ENGINE - FUEL AND CONTROL - ENGINE FUEL AND CONTROL - FUEL SYSTEM TUBES - FUEL SERVO
TUBE WITH REPOSITIONED CLIPPING LUG - CATEGORY CODE 7 - MOD.ENG-73-0053

V2500-ENG-73-0053

Location of fuel servo tube
Fig.1

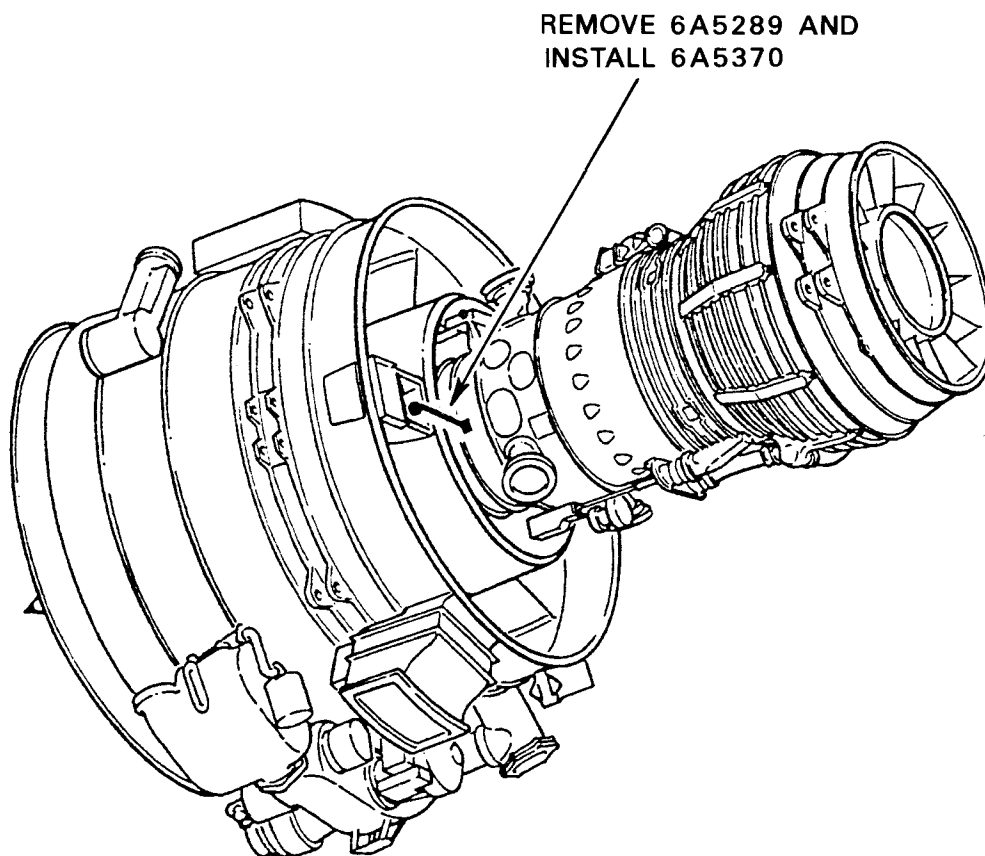
The tube supplying fuel to the B.S.B.V. actuators is replaced by an identical tube on which the clipping lug has been repositioned.

Clip point CP7004A is replaced by CP7004.

REMOVE 6A5289 AND
INSTALL 6A5370

- (1) Install the new clipping assembly in accordance with the approved procedures, ref V2500 Engine Manual, Chapter/Section 72-00-32 and 72-00-42, Installation.
